Proposed Updated Final Safety Analysis Report Tables and Figures
(Mark-Ups; for Information Only)
(164 pages follow)

FINAL PLANT LAYOUT, PLAN C ABOVE
ELEVS. 620'-6", 623'-6" AND
624'-6", PLANT COMPLEX
FIGURE 1.2-5
(DWG. E-013-0005-00000)

Figure 2.3-15

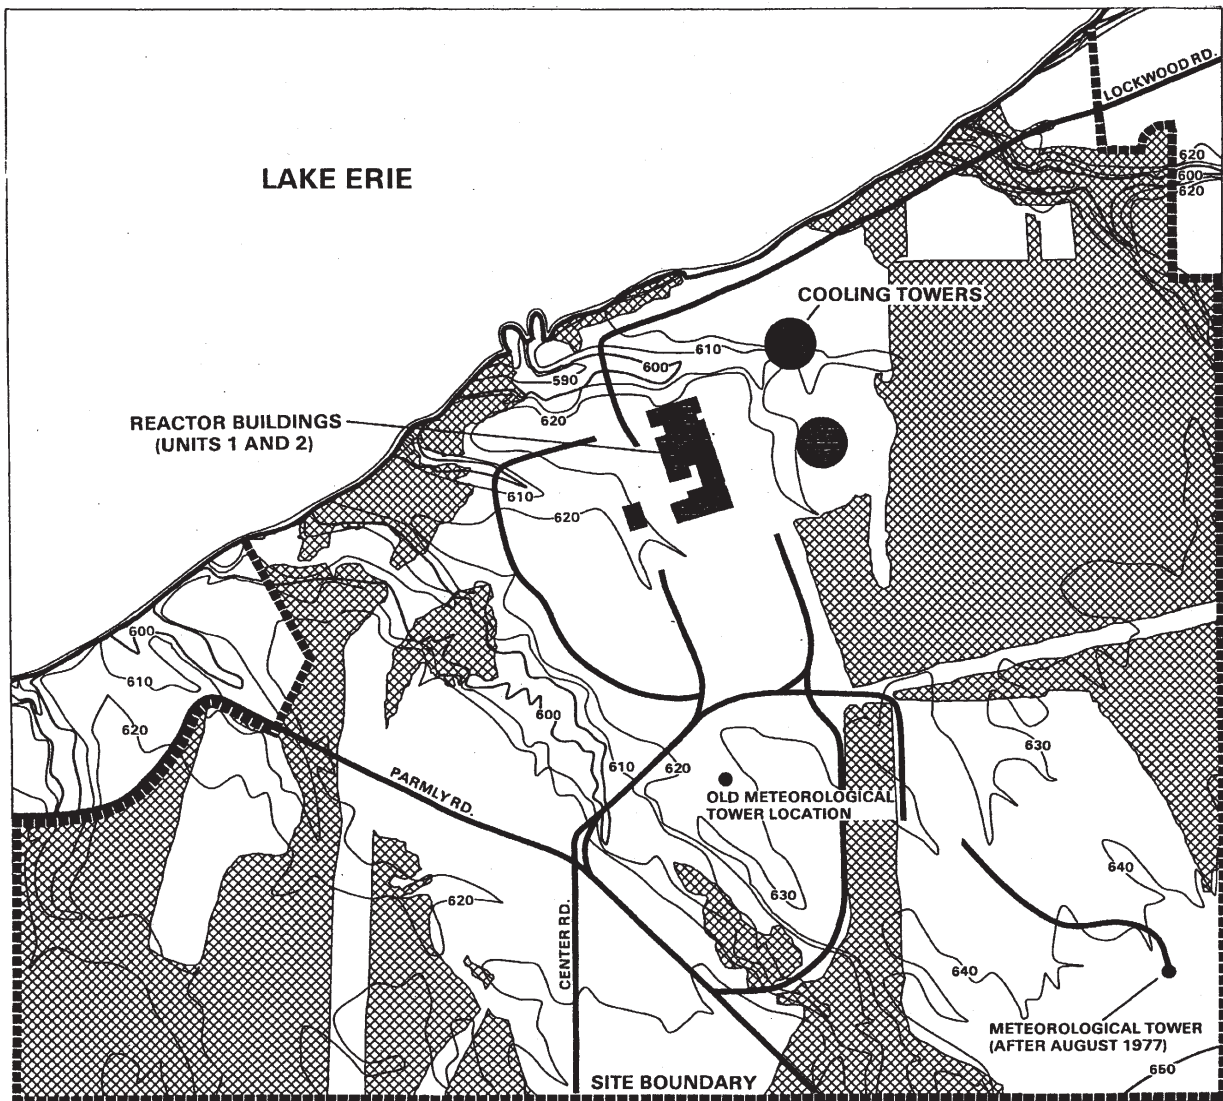
REVISE NOTE
THIS CN

~~Note: Contours do not necessarily reflect regrading from construction.~~

NOTE:
THIS USAR FIGURE CONTAINS
HISTORICAL TOPOGRAPHICAL
INFORMATION FOR REFERENCE
ONLY AND WILL NOT BE UPDATED.

Figure 2.3-17

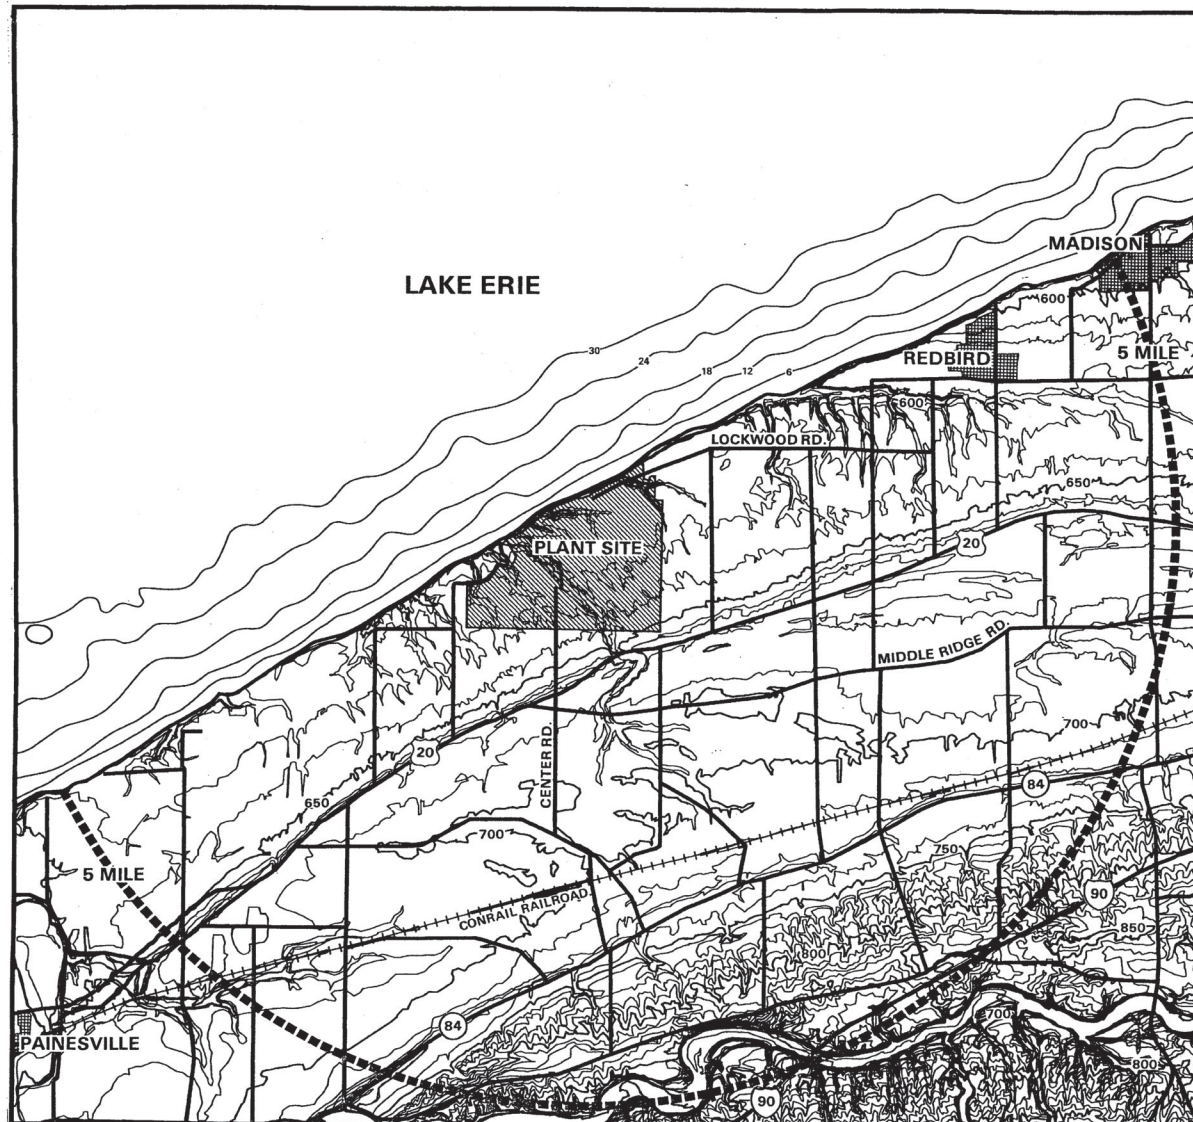
ADD NOTE
THIS CN

NOTE:
THIS USAR FIGURE CONTAINS
HISTORICAL TOPOGRAPHICAL
INFORMATION FOR REFERENCE
ONLY AND WILL NOT BE UPDATED.

FIGURE 2.4-2

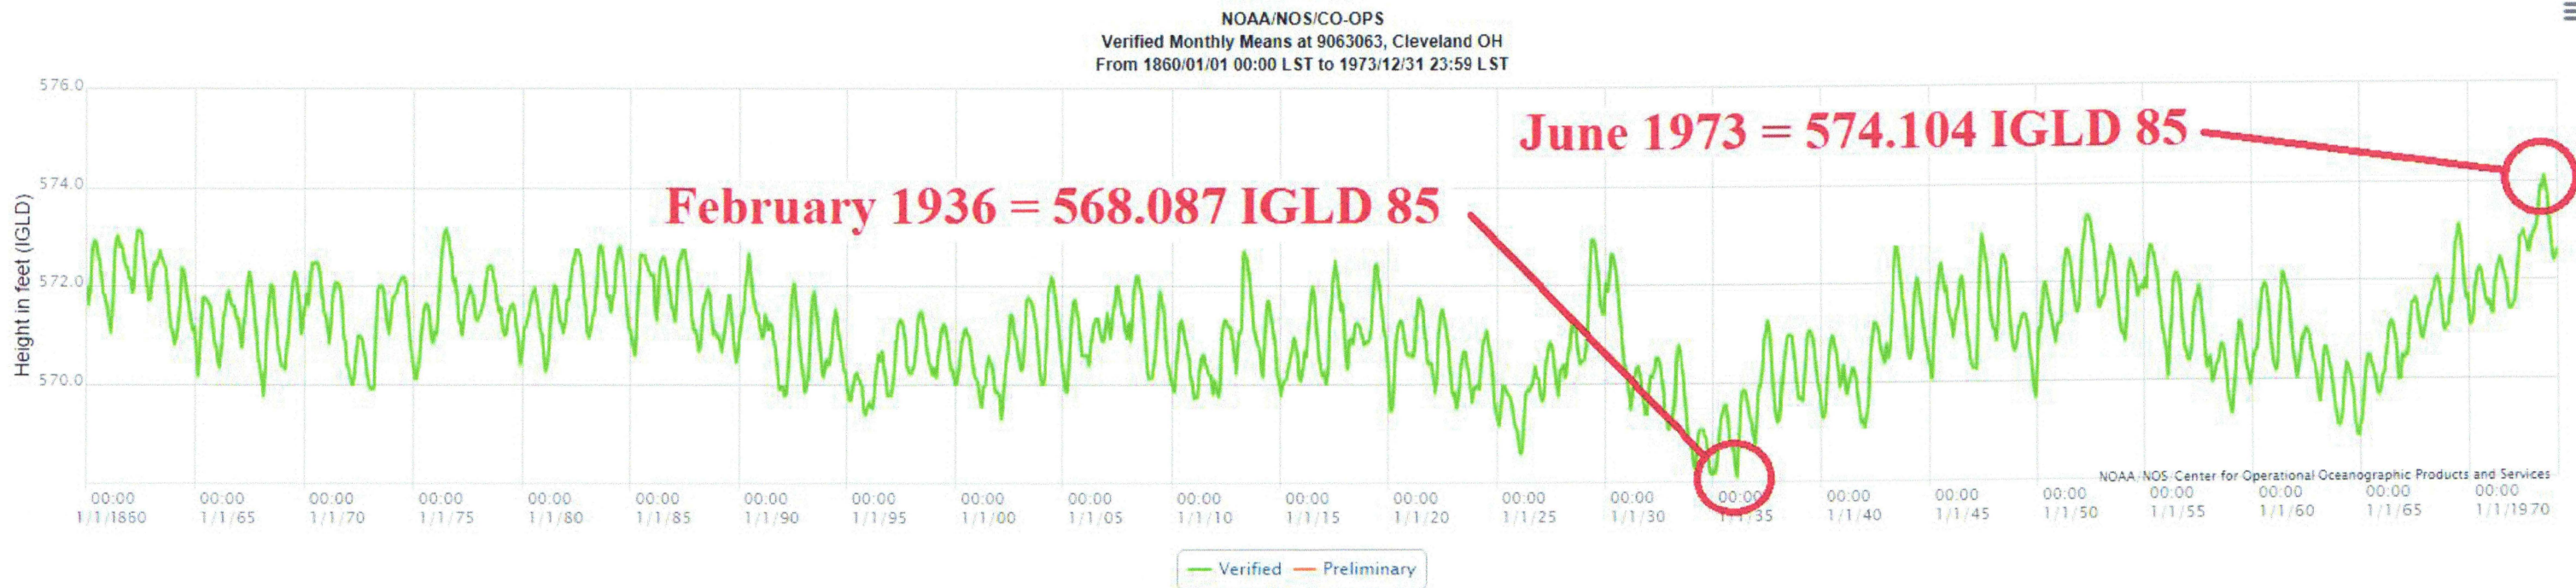
- NOTES:
1. NGVD29 PLD IS THE DATUM REFERENCED FOR BUILDING ELEVATIONS
 2. DATA PRESENTED IN THIS FIGURE SOURCED FROM PNPP CALCULATION 50:74.000
 3. AMBIENT HIGH WATER BASED ON HIGHEST MEAN MONTHLY AVERAGE = 575.4 FT PLD
 4. AMBIENT LOW WATER BASED ON LOWEST MEAN MONTHLY AVERAGE = 569.3 FT PLD
 5. MAXIMUM STILLWATER LAKE LEVEL ELEVATION = 580.5 FT PLD

NOTE (NOT FOR INCORPORATION: FIGURE 2.4-2 REVISED IN ITS ENTIRETY.)

CHANGE TITLE
THIS CN

TOPOGRAPHY AND STORM
DRAIN COMPOSITE
FIGURE 2.4-3
(DWG. D-743-0013-00000)

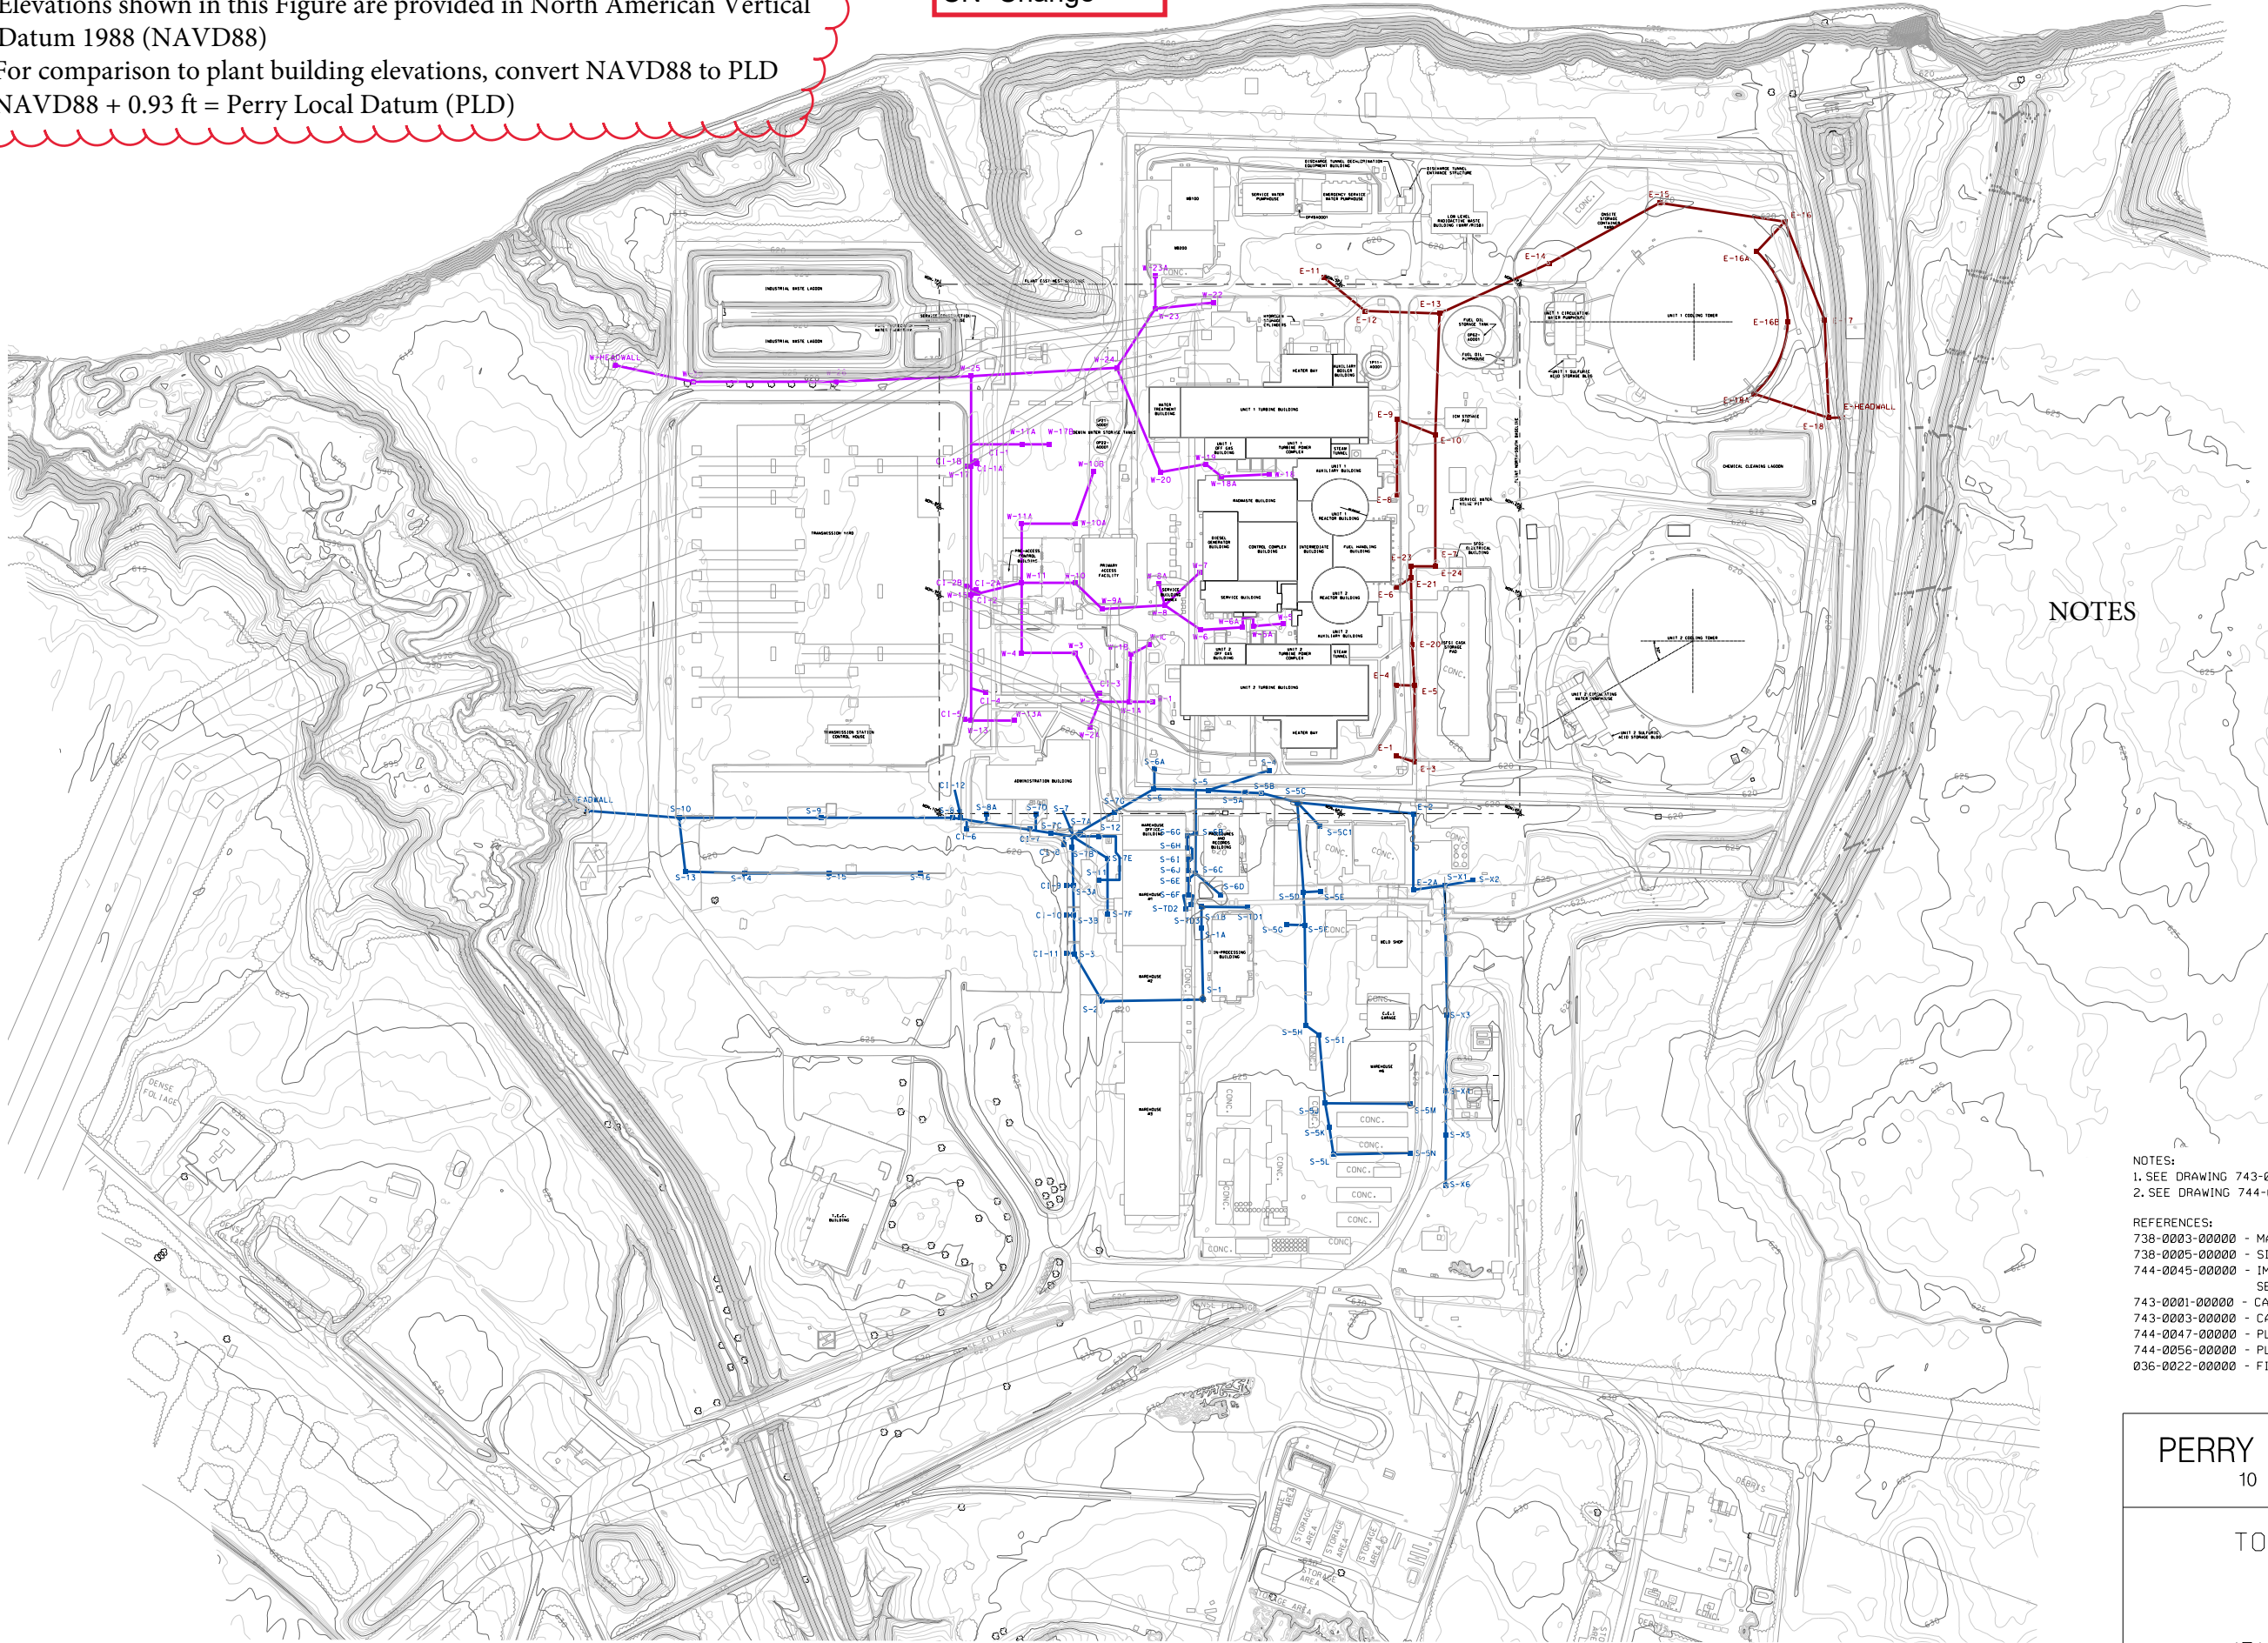
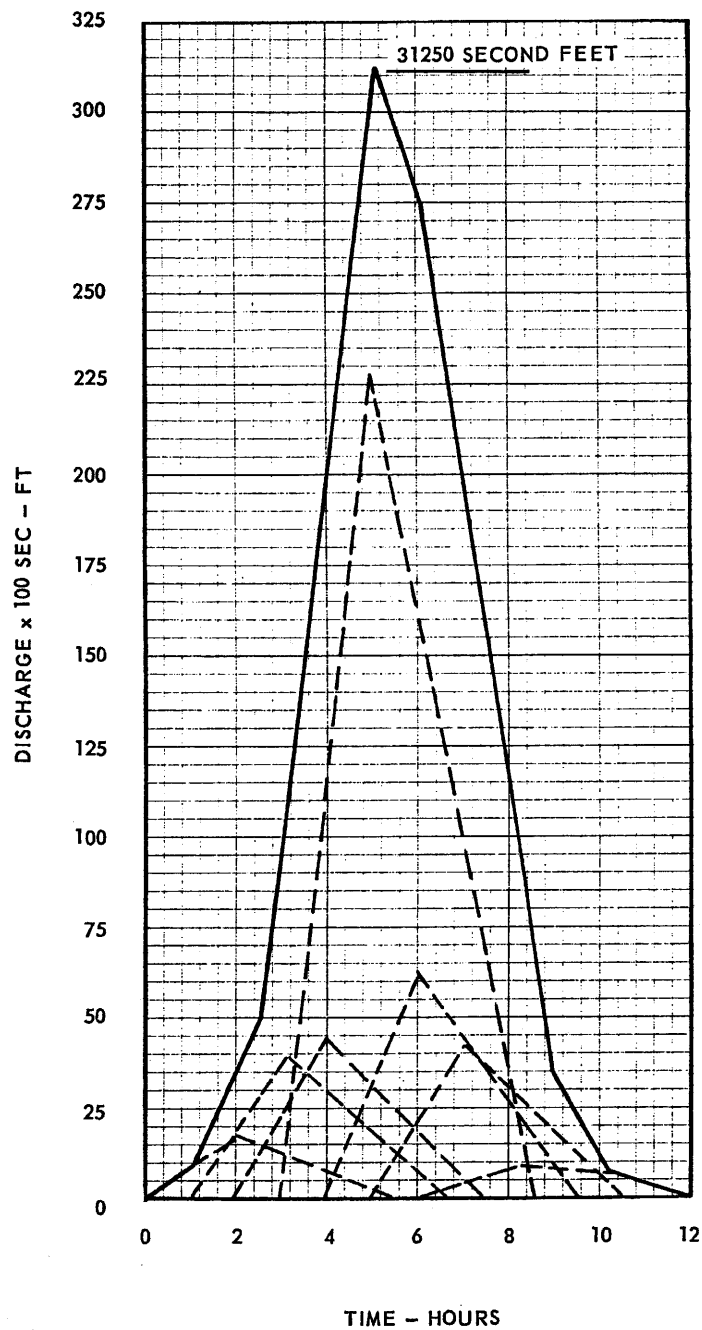
- 1. Elevations shown in this Figure are provided in North American Vertical Datum 1988 (NAVD88)
- 2. For comparison to plant building elevations, convert NAVD88 to PLD
- 3. NAVD88 + 0.93 ft = Perry Local Datum (PLD)

NOTE (NOT FOR INCORPORATION):
THIS ENTIRE FIGURE HAS BEEN REVISED.
